Requested Action: Site Plan Approval Extension.

PLANNING COMMISSION STAFF REPORT

STAFF REPORT: Case # 25-3888 6859 Cascade Rd
REPORT DATE: September 15, 2026
PREPARED FOR: Cascade Charter Township Planning Commission
MEETING DATE: October 5, 2026
PREPARED BY: Dan Swallow, Planning Director

APPLICANT: International Beverage, Rishi Makkar
ADDRESS: 6859 Cascade Road
PARCEL NUMBERS: 41-19-09-451-023
REQUESTED ACTION: Site Plan Approval Extension
REQUIREMENTS: Section 14.7 Site Plan Review, E. Effective Date.
EXISTING ZONING: Cascade Village Core (V-VC)
GENERAL LOCATION: The subject parcel is located on the southwest corner of Cascade Rd. SE and Orange Ave. SE.
PARCEL SIZE: 0.62 Acres
EXISTING LAND USE: Commercial – Retail (Liquor Store)
ADJACENT PROPERTIES: N: V-VC, Commercial – Restaurant (Cascade Roadhouse)
E: V-VC, Commercial – Office (Keystone Realty)
S: V-VC, Commercial – Retail (Bridal Elegance)
W: V-VC, Commercial – Restaurant (Jamn Bean Coffee)
• *Wide Right-of-Way: Cascade Rd. and Old 28th Street*

A5.0

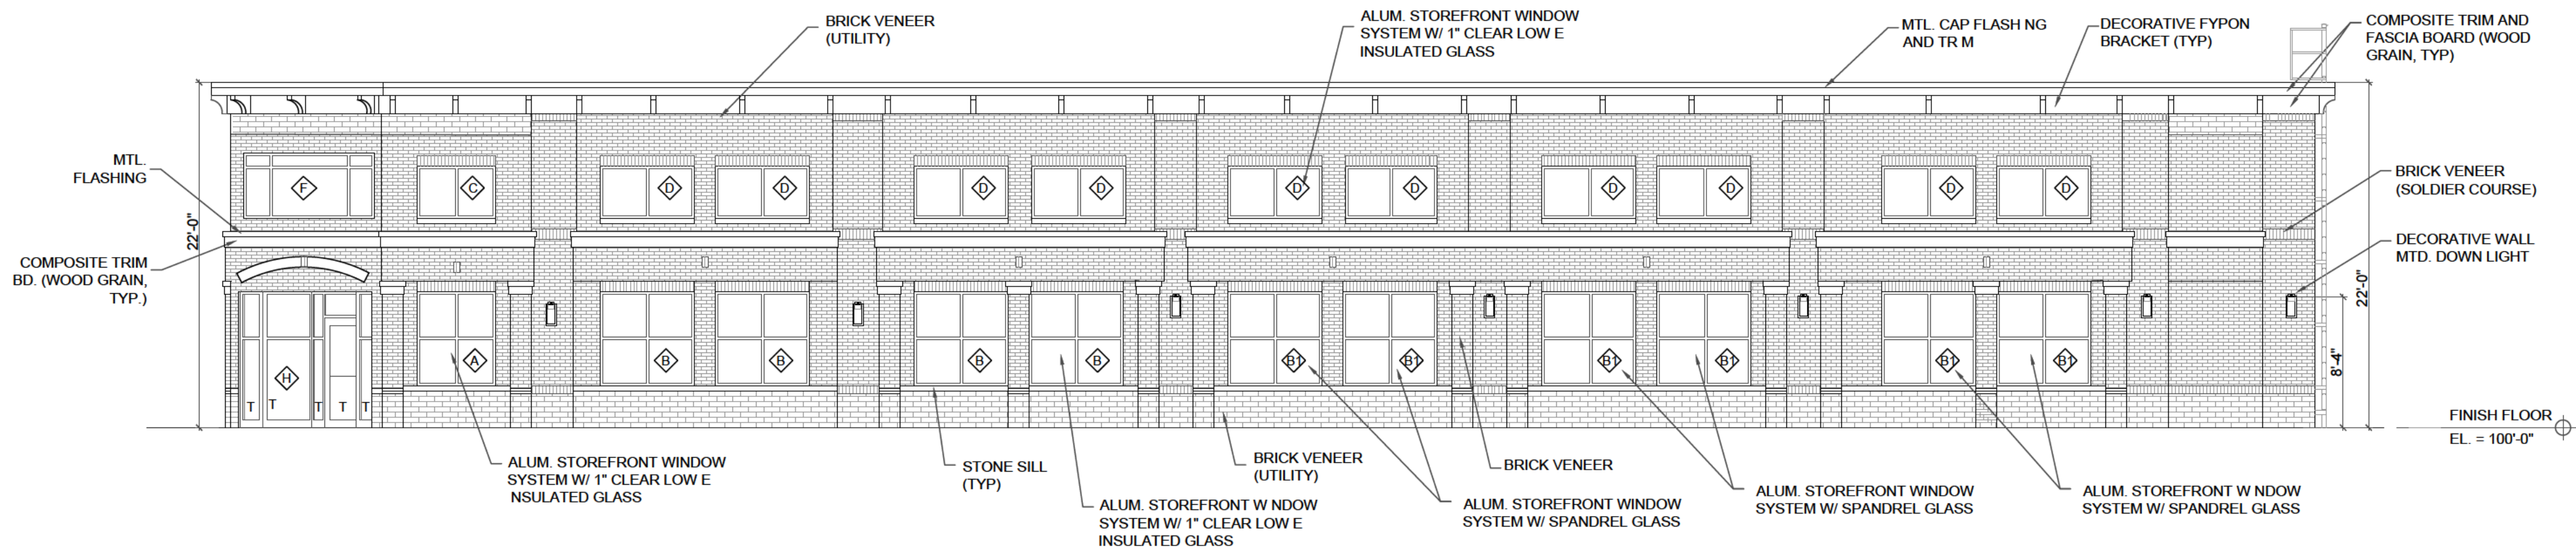
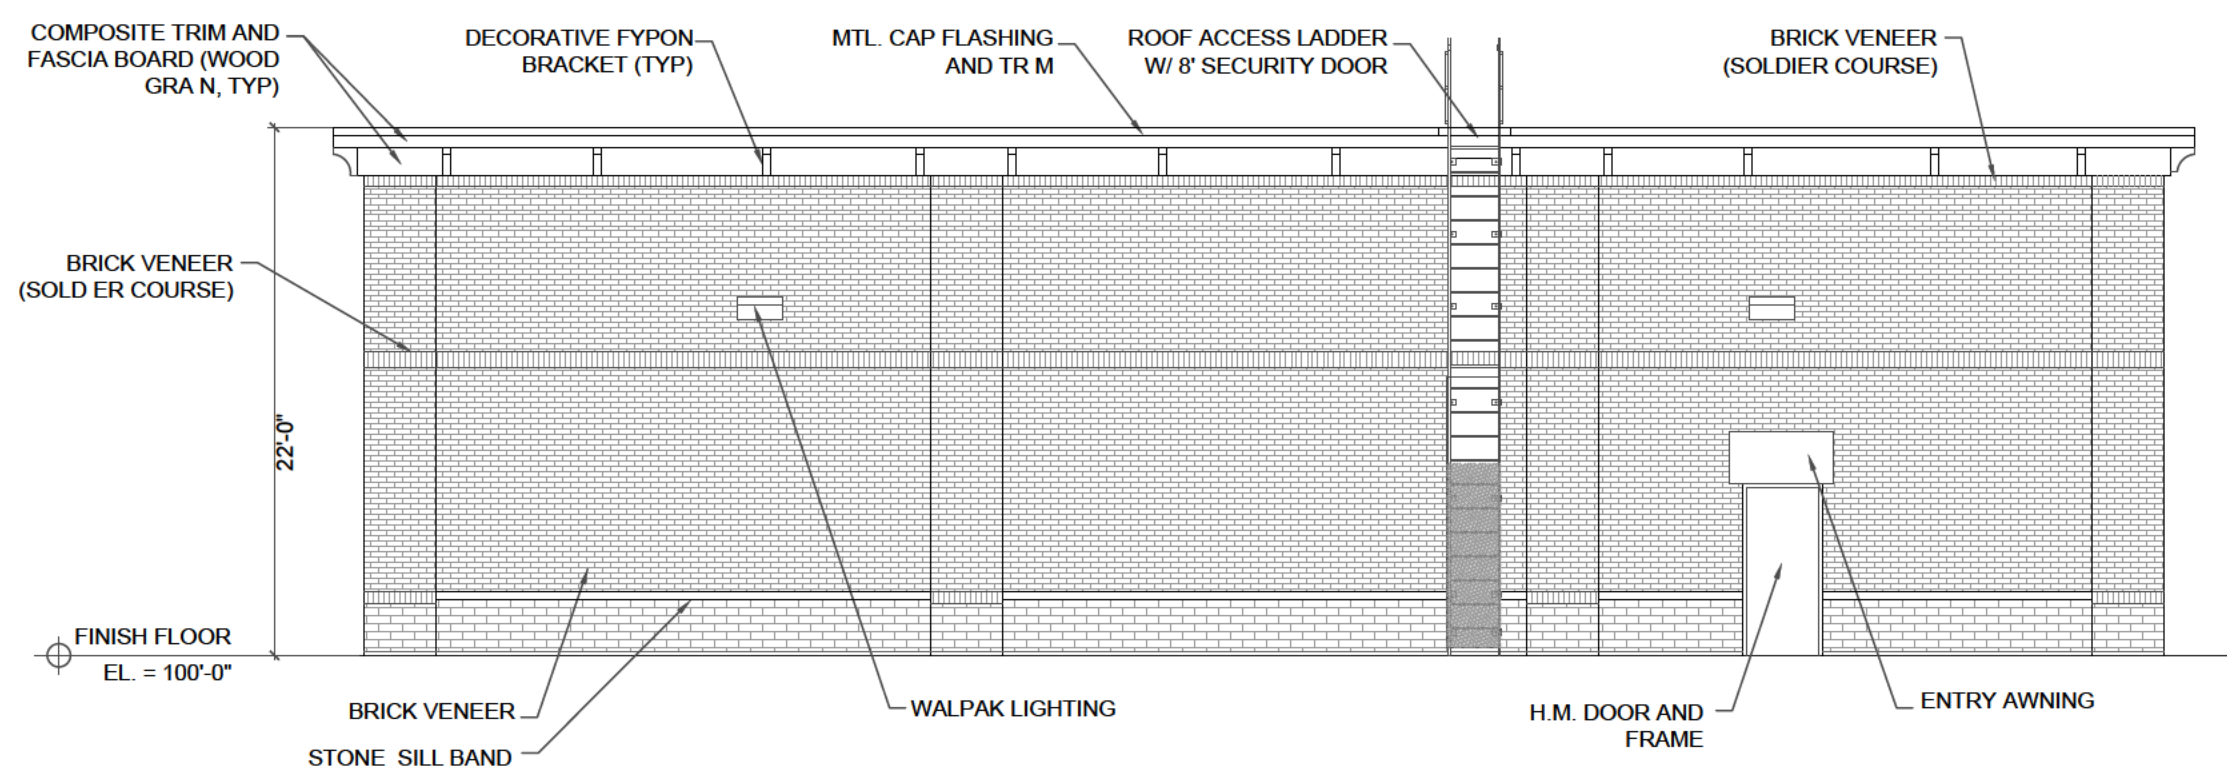
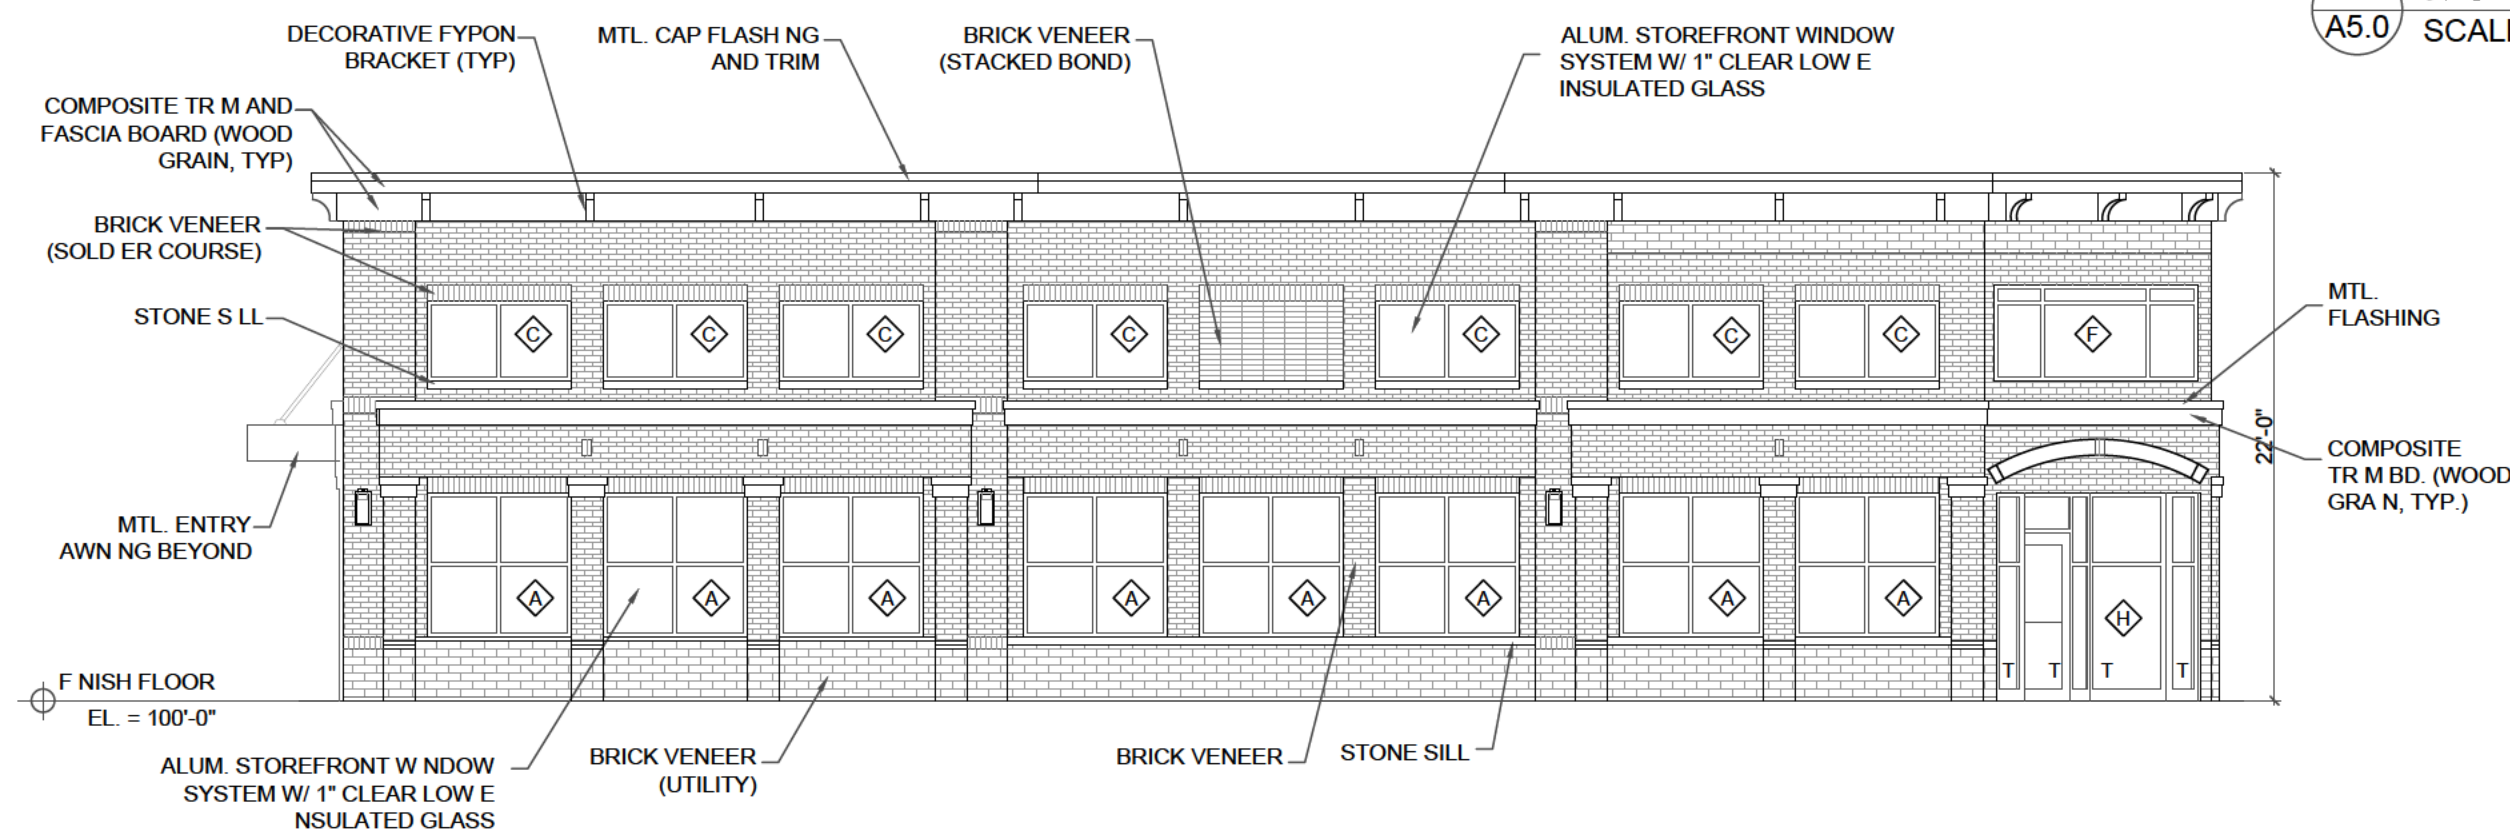
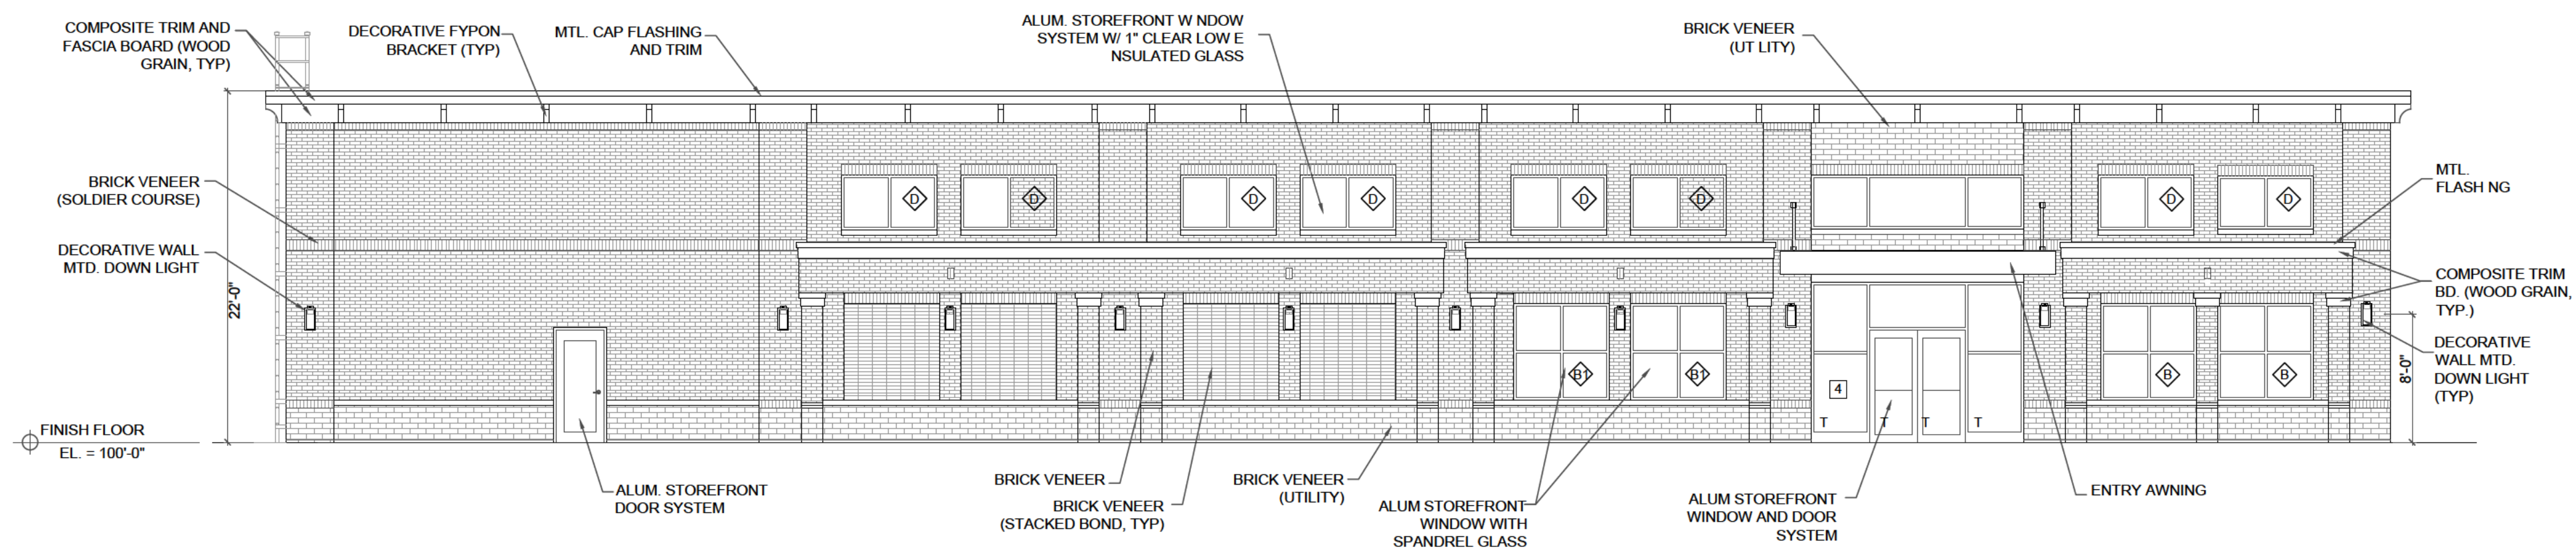
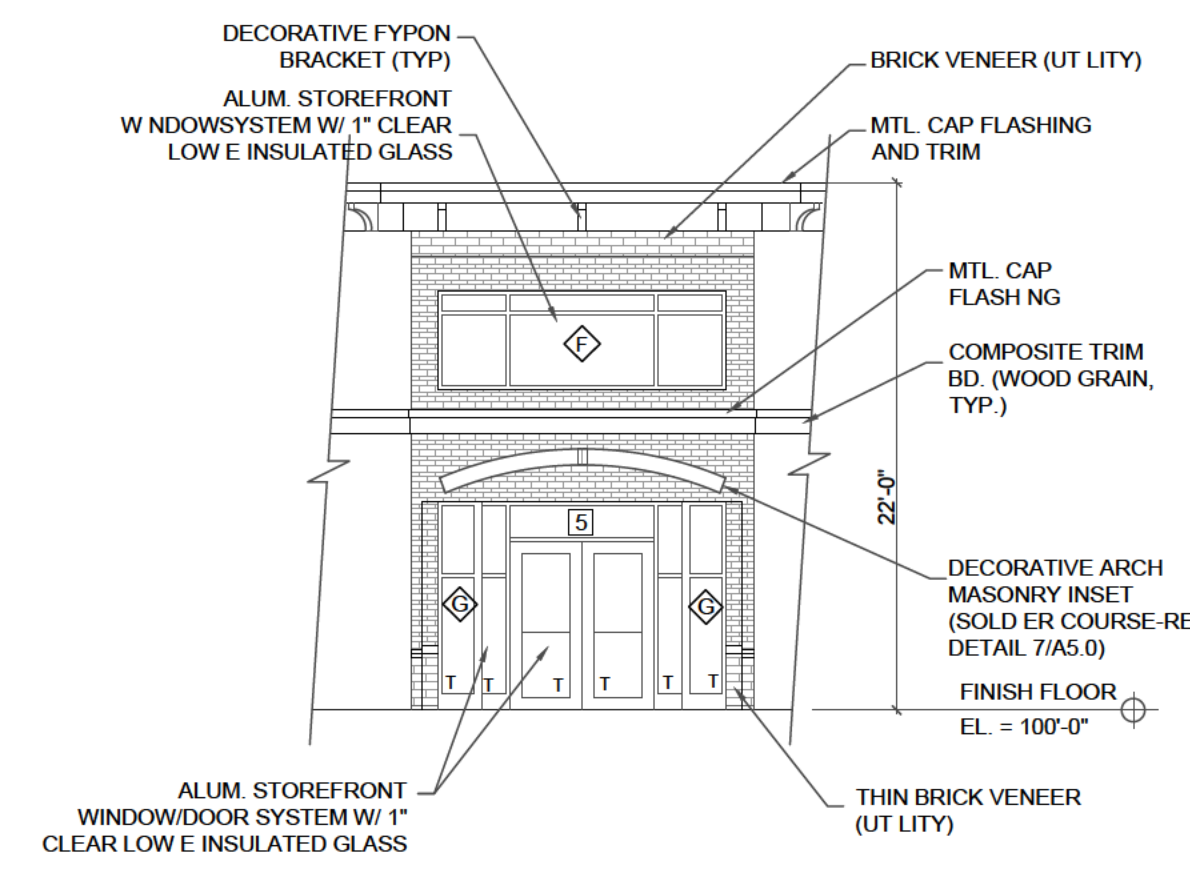
Site Plan Approval Conditions	Progress Made in Interim
1. The VLT (Visible Light Transmission) levels of the	The applicant has revised the elevation drawings and window detail sheets in the

windows be approved by the Planning Department in advance of a building permit.	site plan package to stipulate a “ Clear ” glazing to be installed in the required window openings (Seet Attached Plan Sheets A2.0 and A5.0 from Speed Architects)

1. Window VLT / Building Elevations

Included with this submittal is Sheet A5.0 containing the proposed final building elevations and window configuration for Township review and approval.
